20 December 2024

**The CEO
Northern Beaches Council
PO Box 82
MANLY NSW 2095**

**Statement of Environmental Effects
Modification of Land and Environment Court issued consent
Melwood Avenue Pty Ltd v Northern Beaches Council [2024] NSWLEC 1771
Seniors Housing
69 Melwood Avenue, Forestville**

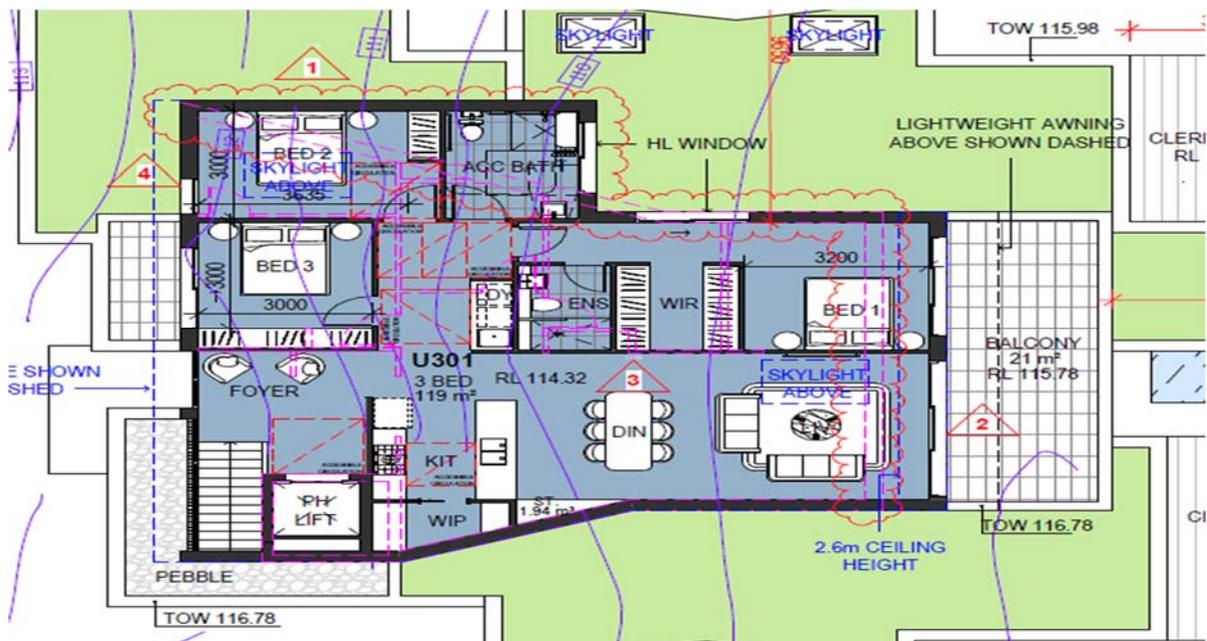
The modifications on the Ground level, Level 1 and Level 2 are generally contained within the approved envelope such that the 3-dimensional form, the streetscape appearance and the landscape outcomes as approved, are not compromised as a consequence of the modification sought. The image below shows the changes to Unit 201's northern setback provides for a 1 metre reduction in setback.

There is no change to landscaped area and a minimum setback of 3 metres is achieved.

To assist in Council's assessment of the impact of the proposed modification to unit 301 we set out the SEPP (Housing) 3 storey building envelope diagrams for the approved DA and modification below:

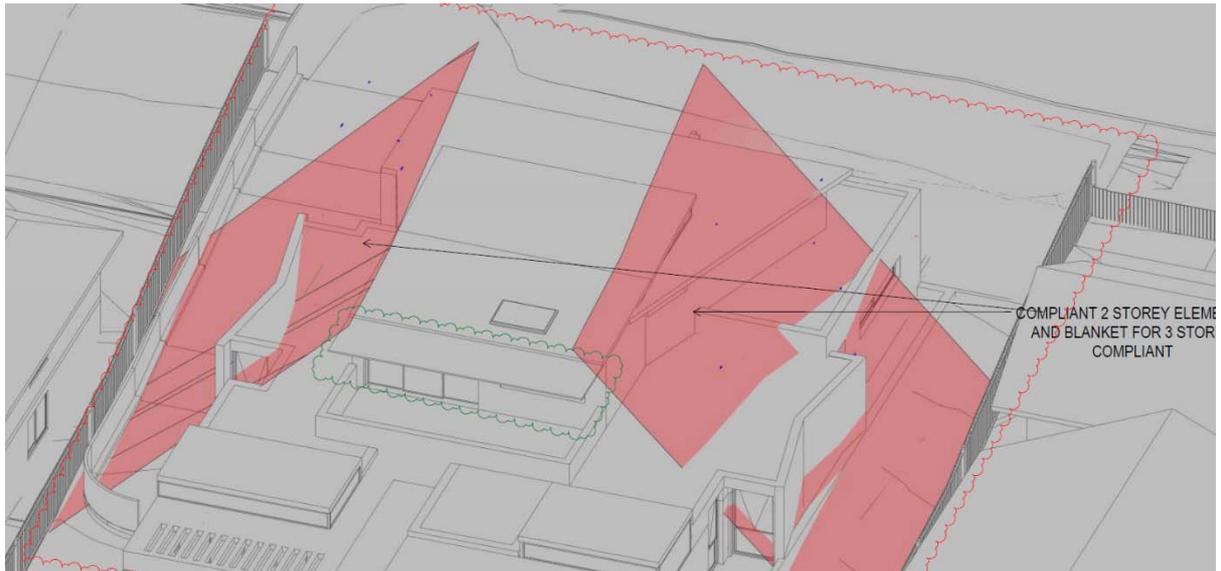
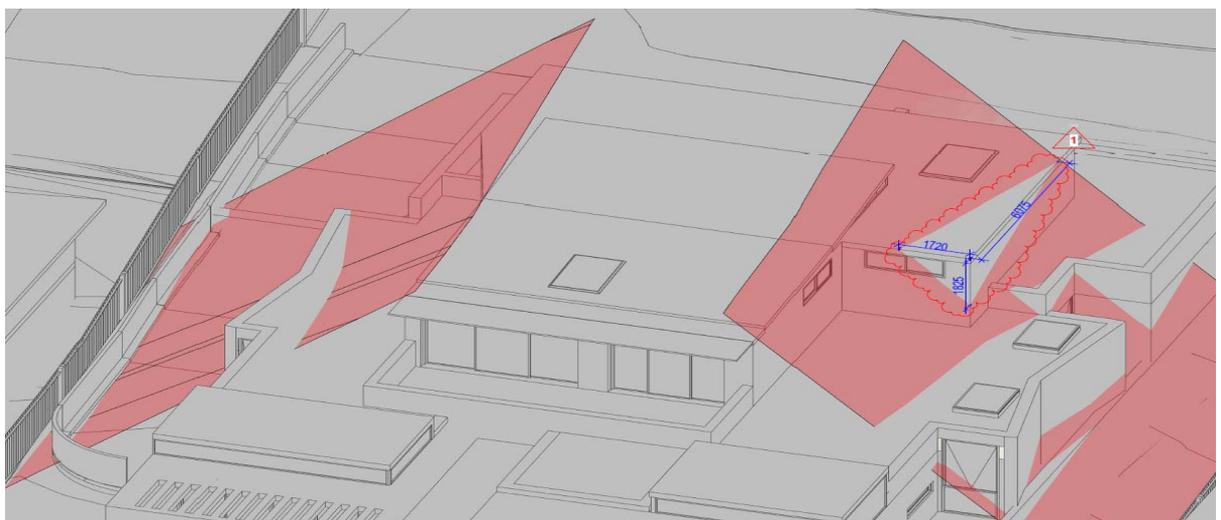
Level 3 seeks a modification to properly align Unit 301 to be parallel with the subdivision layout and extend the eastern wall by 1.2m. The relevant part of these plans is shown below:

Approved DA –

Proposed Modification -

Portions of the proposed 3rd storey elements protrude beyond the prescribed building plane as shown in the Building Planes Diagram as follows:

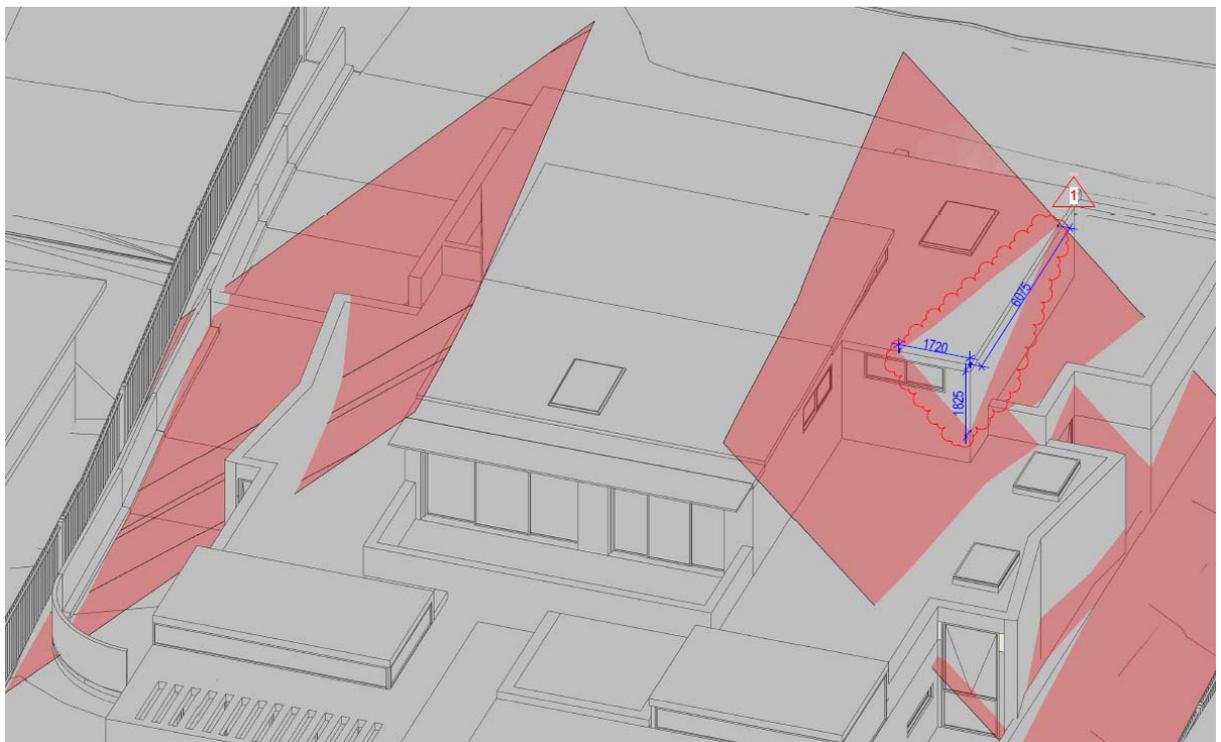
Approved DA –

Proposed Modification -

The breach occurs on the northern side of the Level 3 apartment where a portion of the northern facade exceeds the standard by a maximum of 3.1 metres. I note that the western street facing façade and southern façade of the Level 3 apartment are 2 storeys in height.
